COMMITTEE OF EXPERTS ON THE TRANSPORT OF DANGEROUS GOODS AND ON THE GLOBALLY HARMONIZED SYSTEM OF CLASSIFICATION AND LABELLING OF CHEMICALS

Sub-Committee of Experts on the Transport of Dangerous Goods

EXPLOSIVES, SELF-REACTIVE SUBSTANCES AND ORGANIC PEROXIDES

Amendments to the Manual of Tests and Criteria

Fig. 1: Pressure curves from the bursting of 16 steel tubes, curves horizontally shifted

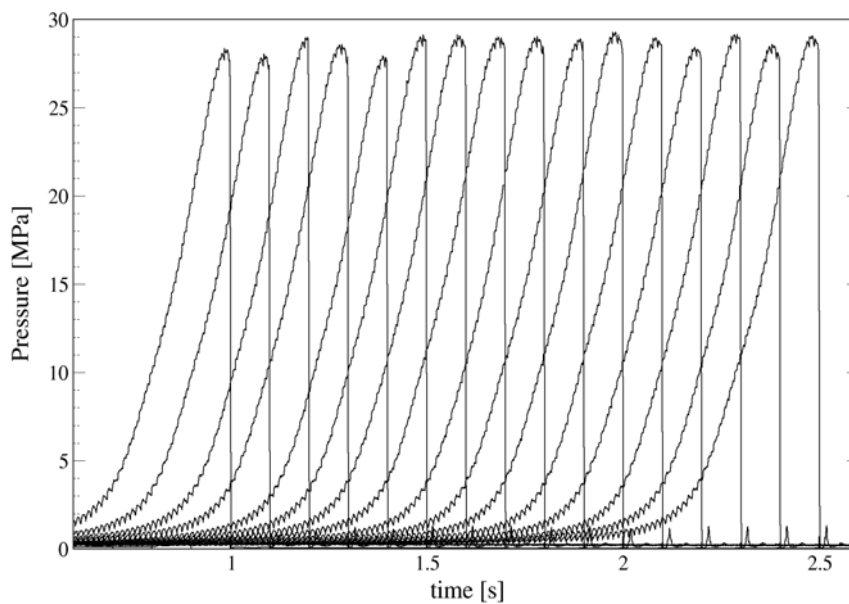
The diagrams shown in Fig. 1 and 2 are pressure traces and peak values from the quasi-static bursting of Koenen test-tubes under oil pressure. The data has been analysed to form Fig. 2 with the peak values from the curves, i. e. the highest pressure recorded before the bursting occurred.

Fig. 2: Bursting pressures for 16 steel tubes tested, statistical analysis

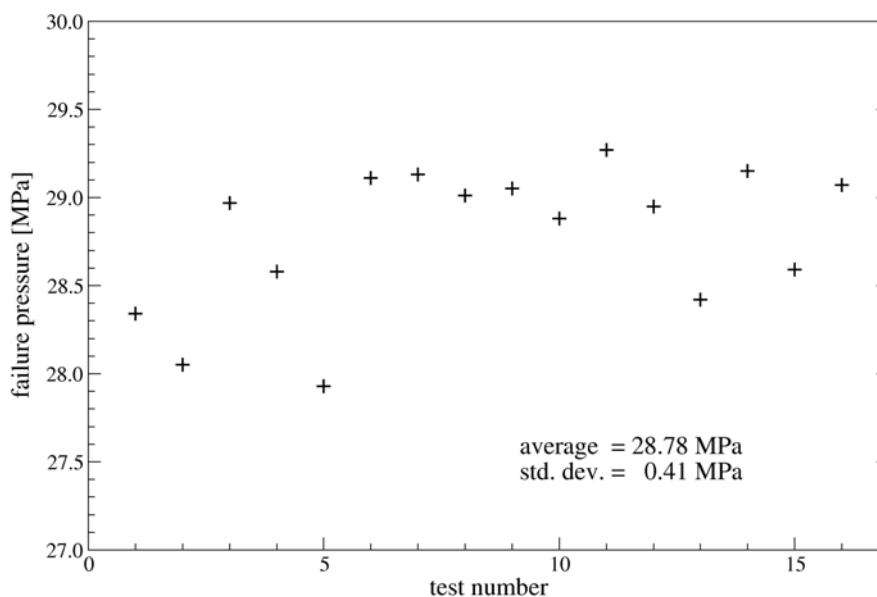
The data from Fig. 2 fit into the earlier given interval for the bursting pressure of 300 bar \pm 30 bar. Regarding more or less accurate definition of testing conditions, it is a matter of considerations to which detail this description shall go. The more limiting the parameters are set out, the more difficult it will be to comply with the requirements. There has to be a reasonable balance of defining parameters not as accurate as possible, but as accurate as appropriate. While the former description was in fact not very accurate, the proposal made here is already fairly restrictive.

For quality control of the steel tubes 1% of the tubes from each production lot shall be subjected to quality control and the following data shall be verified: (a) the mass of the tubes shall be 26.5 ± 1.5 g, tubes to be used in one test sequence shall not differ in weight by more than 1 g; (b) the length of the tubes shall be 75 ± 0.5 mm; (c) the wall thickness of the tubes measured 20 mm from the bottom of the tube shall be 0.5 ± 0.05 mm. (d) the bursting pressure as determined by quasi-static load through an incompressible fluid shall be 30 ± 3 MPa.
